TENNESSEE VALLEY AUTHORITY
CHATTANOOGA, TENNESSEE
37401

February 15, 1974

In the Matter of Applications) Docket Nos. 50-438
Tennessee Valley Authority) 50-439

This is in response to William H. Regan's letter of January 4, 1974, in which it was stated that the proposed intake design for the Bellefonte Nuclear Plant is considered unsatisfactory from an environmental standpoint. It was also stated as a general criterion that water should be taken from a region that has a low density of entrainable organisms, principally fish eggs and larvae, and a low potential for fish congregation and fatigue-producing conditions. The AEC Regulatory Staff then concluded that shoreline intakes, such as proposed for Bellefonte, do not meet this criterion, that they are not satisfactory from an environmental standpoint, and that alternative systems must be studied. We believe that the general criterion is incomplete since it fails to address safety and economic considerations. Moreover, the conclusion reached is not justified when considering the particular circumstances at Bellefonte.

ESSENTIAL RAW COOLING WATER		
ALTERNATE No. 6		
COOLING POND		
BELLEFONTE NUCLEAR PLANT TENNESSEE VALLEY AUTHORITY DIVISION OF ENGINEERING DESIGN		
SUBMITTED	RECOMMENDED	APPROVED
KNOXVILLE	88 C 4	10SNF43
RECORD DRAWING AS CONSTRUCTED

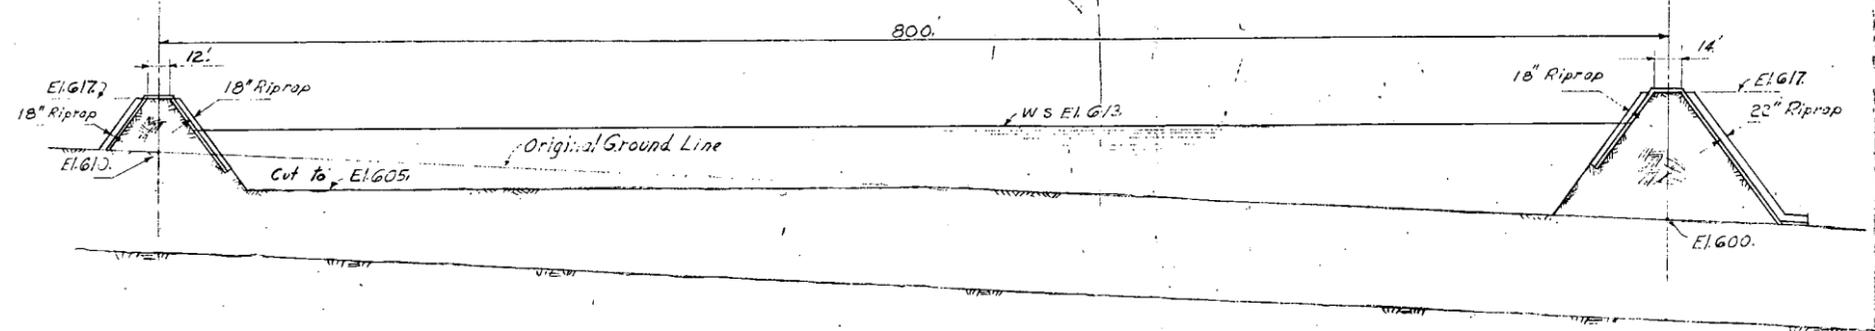
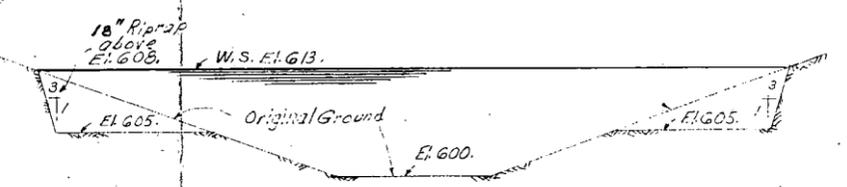
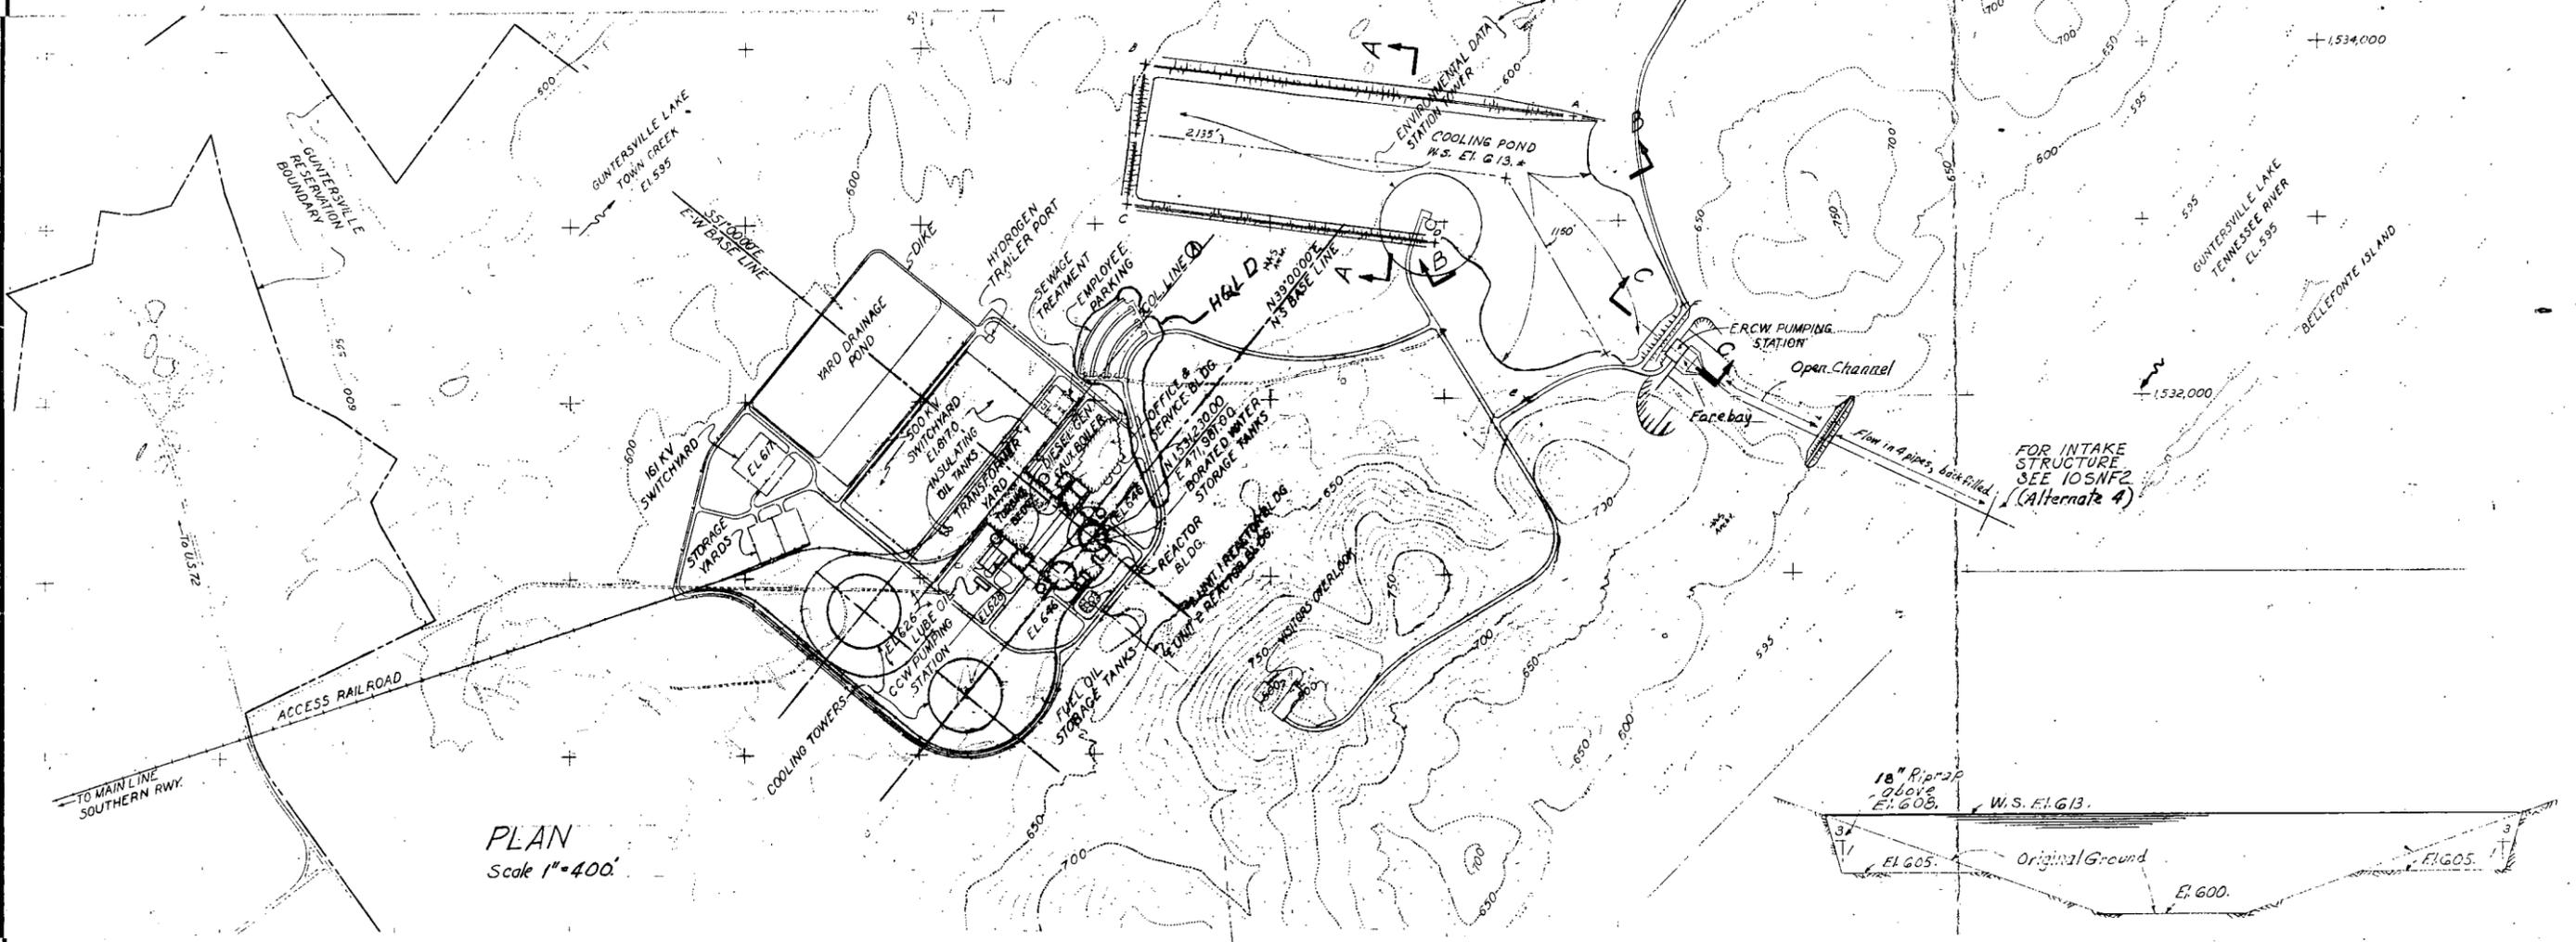
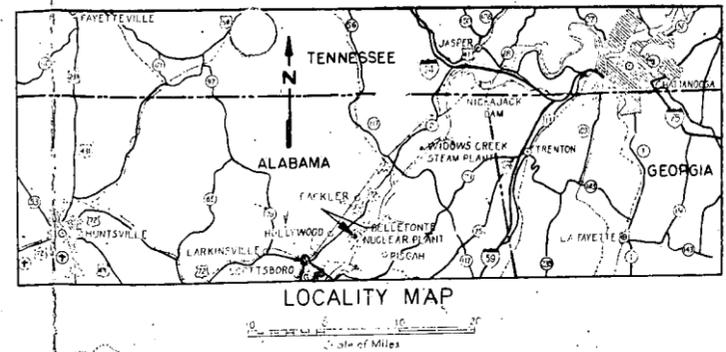
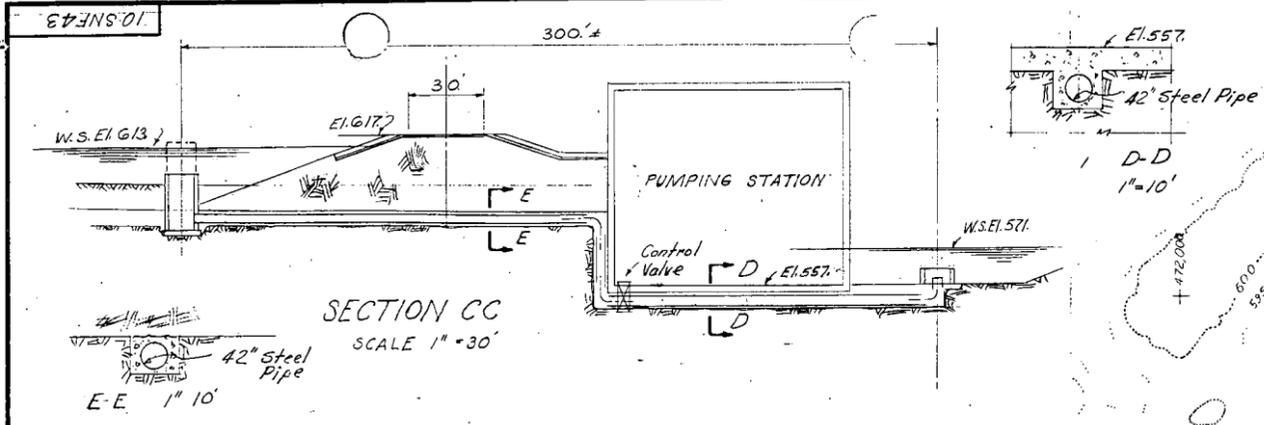
This alternate consists of a deepwater intake as shown by Figure 20-3 identified as alternate 4 (except redundant inlet piping was not provided) in the response to question 20, together with a 60-acre cooling pond as a backup in the event the deepwater intake becomes blocked. The layout is given in Figure 10SNF43 (enclosed) consisting of dikes to form the pond, and a water conduit with a control valve to pass water from the pond to the intake forebay. The pumping station connects to the reservoir as shown in Figure 20-3 of the October 25 submittal.

If the deepwater submerged intake becomes blocked, shutting off the flow to the pumping station, then the control valve under the pumping station opens at a predetermined water level in the intake channel permitting the cooling water to be circulated from the intake forebay to the plant, the plant to the cooling pond, and the cooling pond to the intake forebay. These modifications would result in a cost increase of about \$1.45 million.
